**RE: Comments on Preliminary Flood Insurance Rate Map and Flood Insurance Study for the City of Ukiah Including the Areas Near Orrs, Gibson, and Doolin Creeks**

<b>To</b>	City of Ukiah		
<b>Copy to</b>	GHD Files		
<b>From</b>	GHD and the City of Ukiah	<b>Tel</b>	+1 415 283 4970
<b>Subject</b>	City of Ukiah FEMA Map Revision Review	<b>Project no.</b>	12589077

This memorandum summarizes GHD's and the City of Ukiah's preliminary review of the Mendocino County Map Revision (Orrs, Gibson, Doolin, and Zone AE) Updates, prepared by FEMA Region 9 and presented to the City of Ukiah (the City) in July 2024. This review included the preliminary Flood Insurance Study (FIS) and Flood Insurance Rate Map (FIRM) dated July 10, 2024, and the hydraulic analysis model and data provided by the FEMA's STARR II contractor team on September 11, 2024.

RE: Proposed changes to the FEMA Flood Insurance Rate Maps in and around the City of Ukiah, CA

06045C1512G (1 of 11)

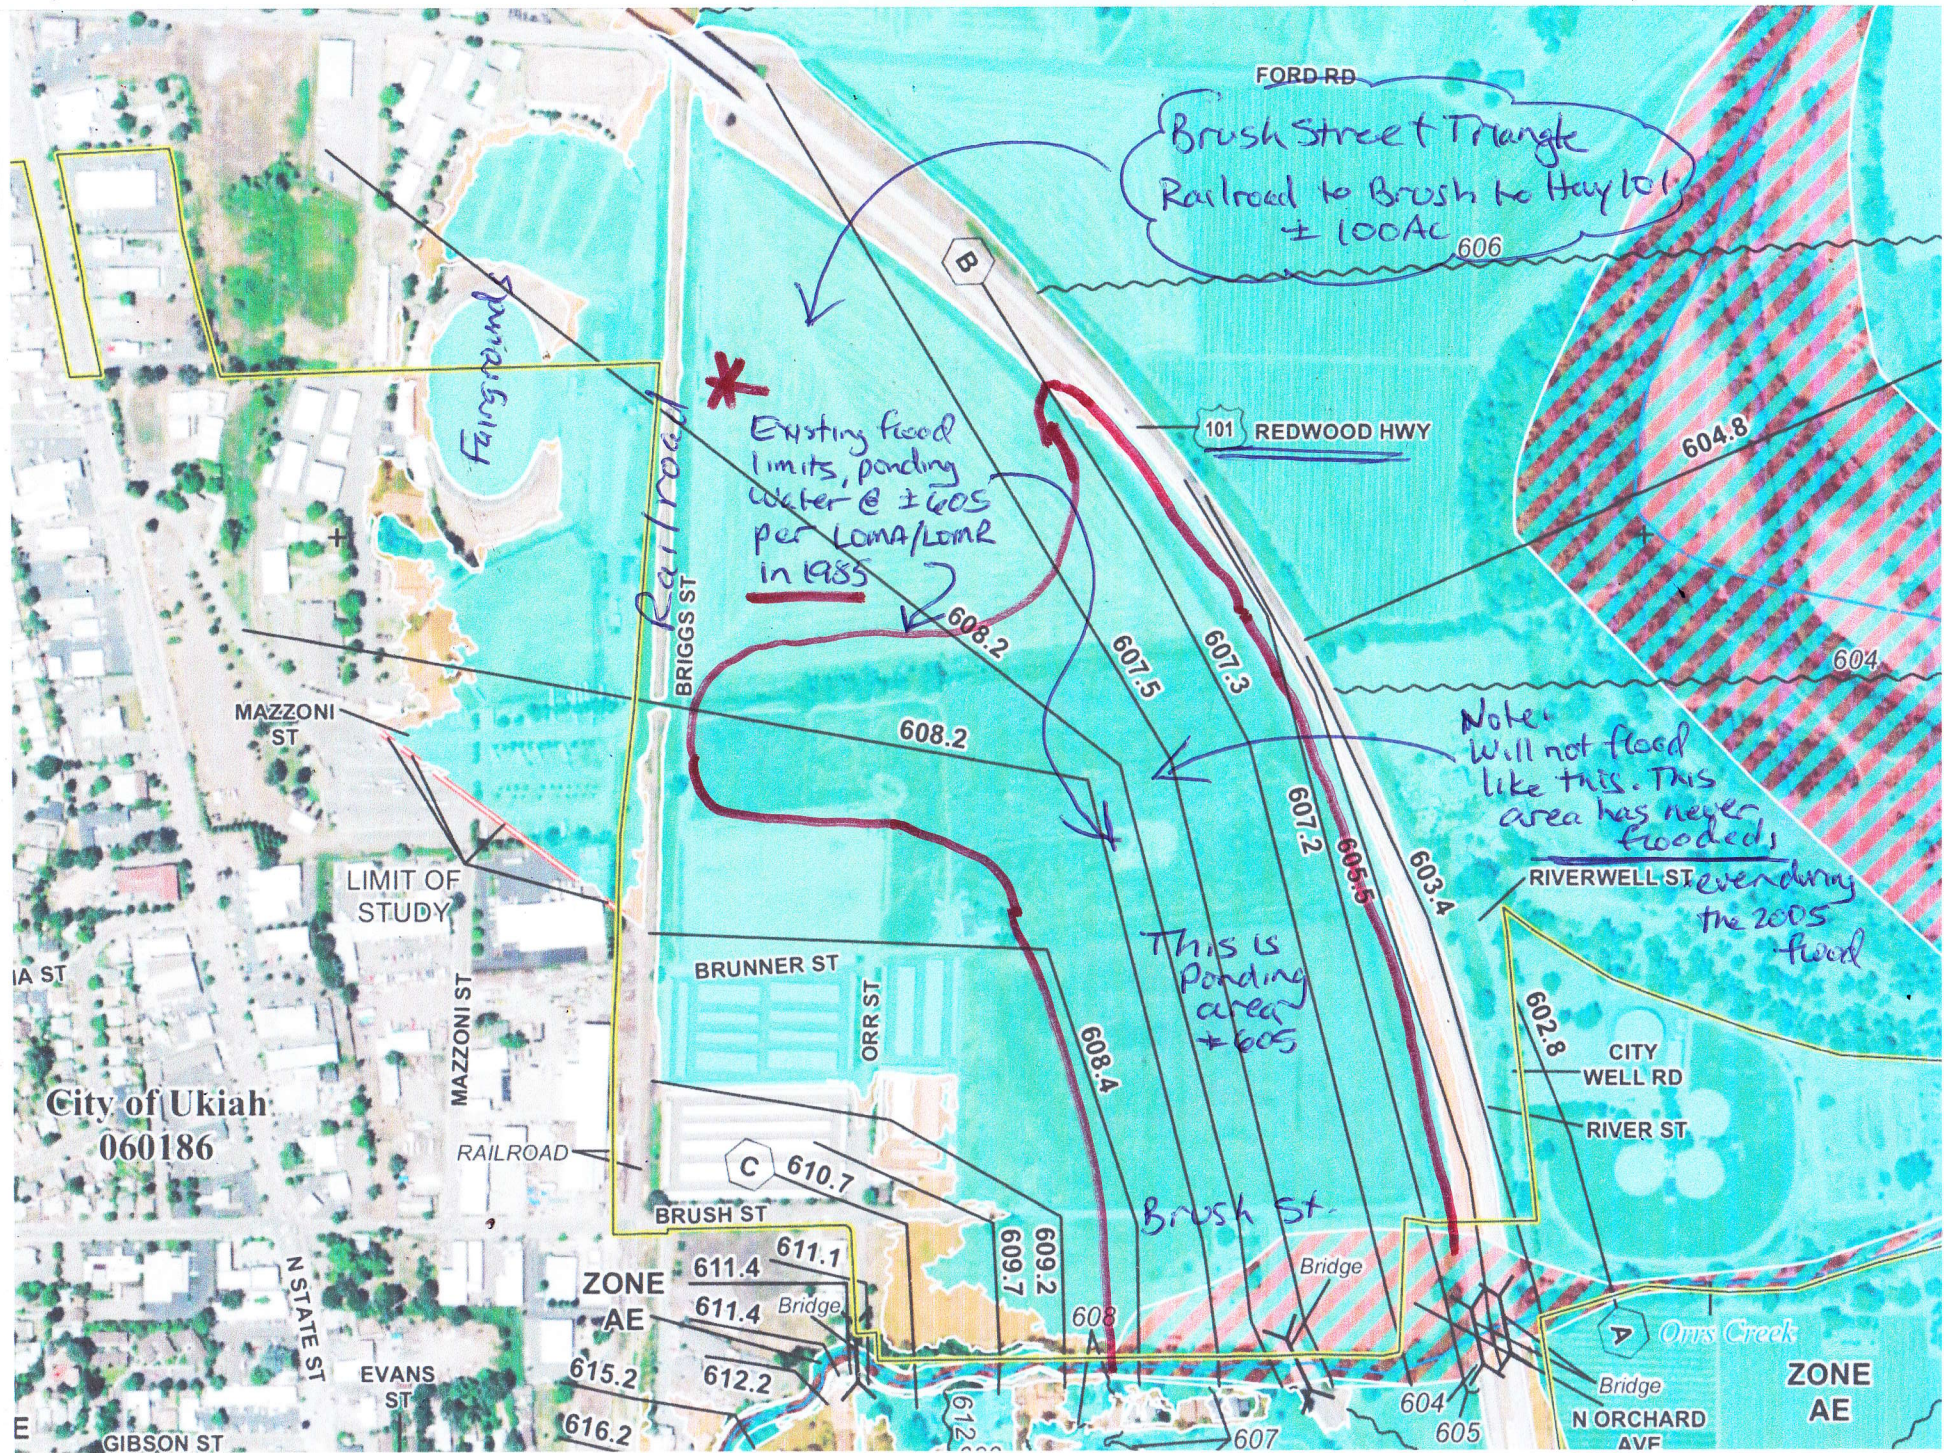
The proposed new flood map for this area shows all of the area north of Orrs Creek flooding with depths 3' or 4' deeper than the existing flood map. It also shows a water surface with fairly steep slopes heading east and generally matching with the water surface slope in the Orrs Creek channel. This is completely impossible. There is no way for flood water to get, over 2000 feet northerly, into this area and then continue flowing easterly at rates of about 8 feet per second and then just stop at the highway. Then once all of this water (probably about 10 times as much as is flowing in the creek channel) somehow just stops at the highway and then magically gets back to the creek channel before it crosses the highway. This will absolutely not happen. If this area floods at all, it will build up about a foot deep at the highway and then cross the highway more than 1000 feet north of Orrs Creek. It will never get back to the creek. Mapping in this area needs to change, flooding will never happen as shown.

Note:  
Will not flood  
like this. This  
area has never  
flooded.  
RIVERWELL ST  
even during  
the 2005  
flood

06045C1514G (2 of 11)

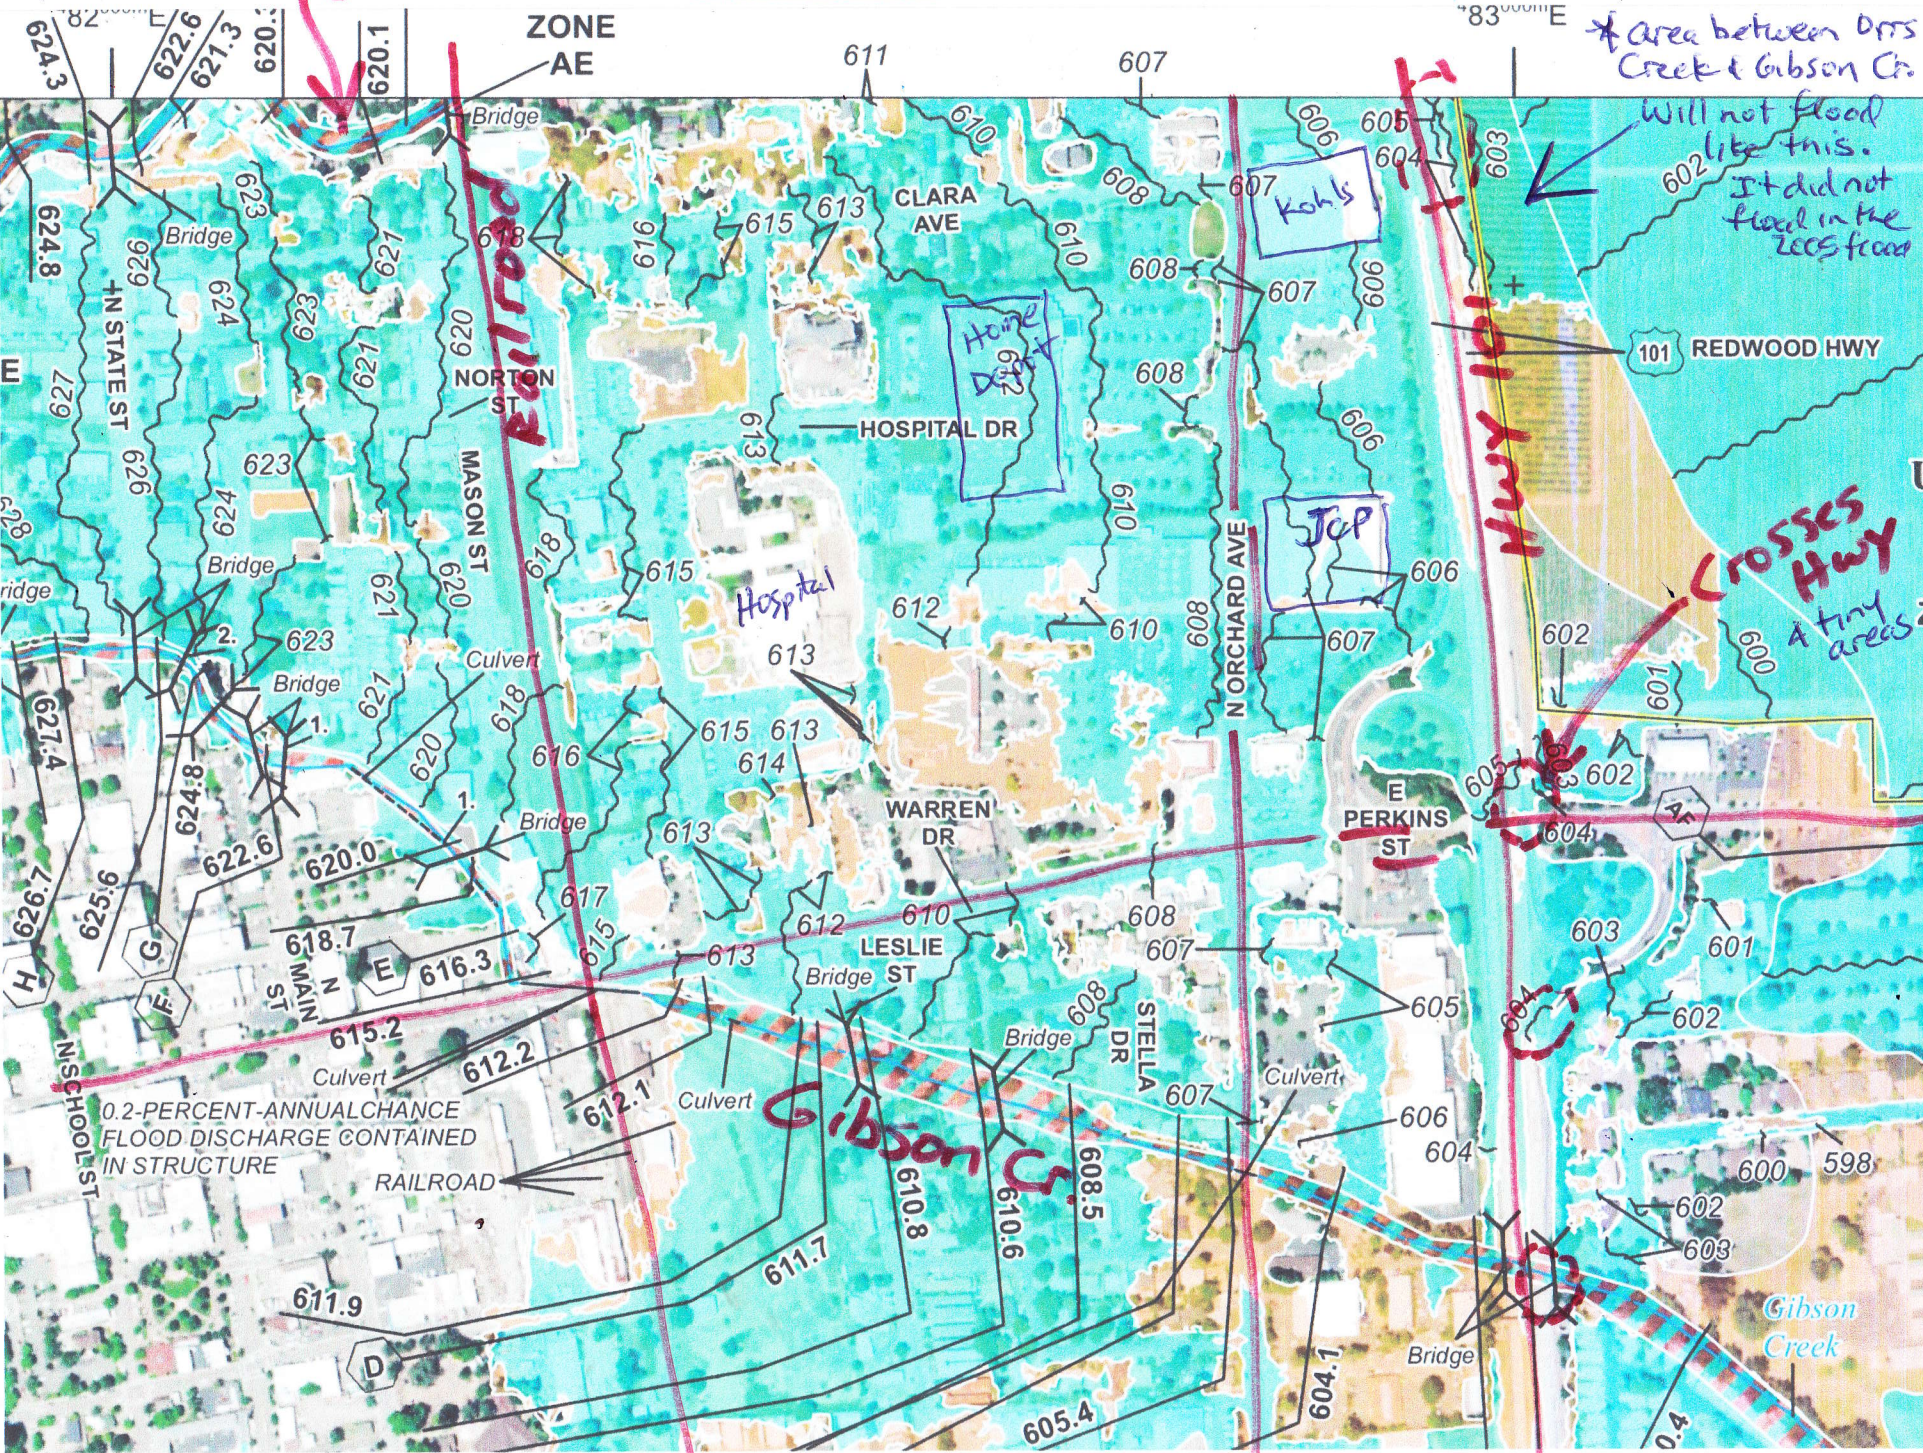
Another general area of concern is the huge area between Orrs Creek and Gibson Creek. This area is mostly residential to the north and west and commercial on the east portion up to Highway 101. None, or very little, of this area is currently in the floodplain. The proposed new map shows all of it being added to the floodplain. The new map also shows a fairly steep water surface which means fairly fast moving water heading east. This massive volume of water then again, just stops at the highway and somehow finds it's way across the highway in 3 or 4 tiny little areas. Again, this is completely impossible. Also, none of this area flooded during the 2005 flood except for minor flooding along the creeks and maybe a little ponding adjacent to the

*Will not flood like this. It did not flood in the 2005 flood*
